Reviewers' comments:

The manuscript discusses a silicon MIS device used as a photoanode for oxygen evolution from water.

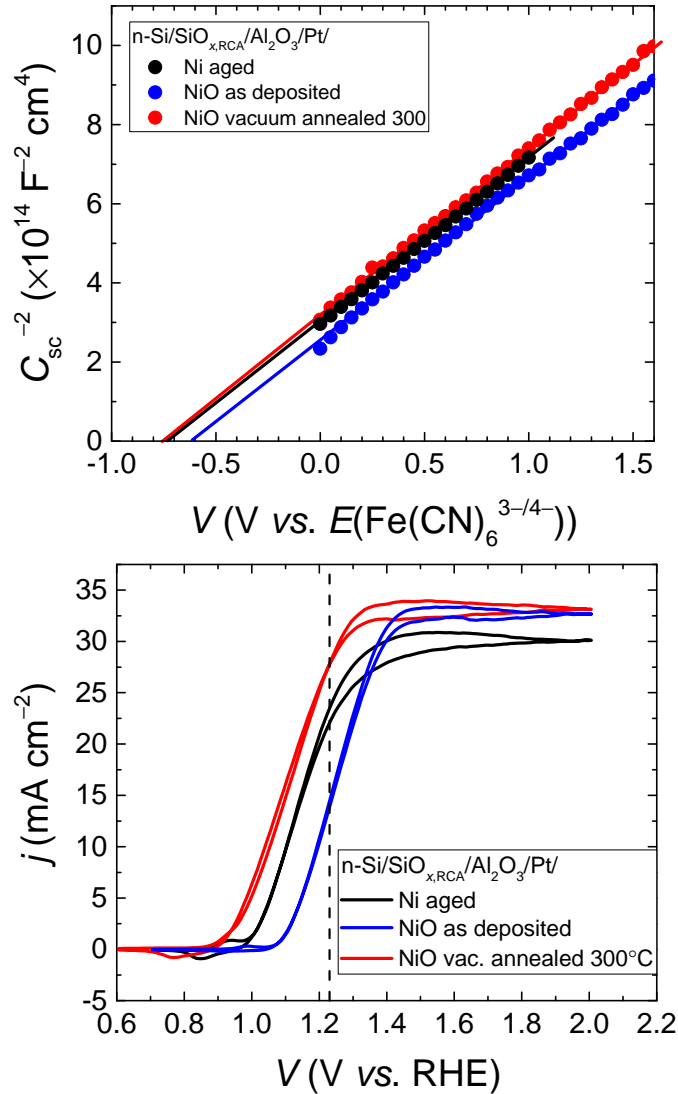
This is an **outstanding paper that is well written and well conceived**. I actually enjoyed reviewing it. The authors engineer the interfacial energetics of a photoanode by using two metals to decouple the functionalities of the Schottky contact and the water oxidation catalyst. They further improve the photovoltage by carefully designing an SiO_x and Al₂O₃ tunnel layer. My only criticism of the paper is that the *stability study as done by poisoning the electrode at a potential of 1.8 V*, well into the plateau region. I suspect that the photovoltage and fill factor may have degraded seriously after the 150 hour irradiation, but this would not be seen in this plot. This could be probed by simply running iV curves such as shown in Fig. 2a before and after the stability study. The other way to look at this would be to do the stability study poised at the maximum power point. If the photoelectrode is still stable under those conditions, this is a truly outstanding result.

We thank the reviewer for this comment and we believe this is an important proof of the stability of our device that we should clarify. We have repeated the illuminated chronoamperometry measurement at a fixed applied potential of 1.7 V *versus* RHE in contact with 1 M KOH, and collected the cyclic voltammetry periodically during 200 hours of operation. We observed that the photocurrent onset potentials *improved* during the prolonged stability test (due to the oxidation/activation of Ni) and showed no noticeable decrease in both onset potential and fill factor over time. This figure can be found in Figure 8b, page 7:
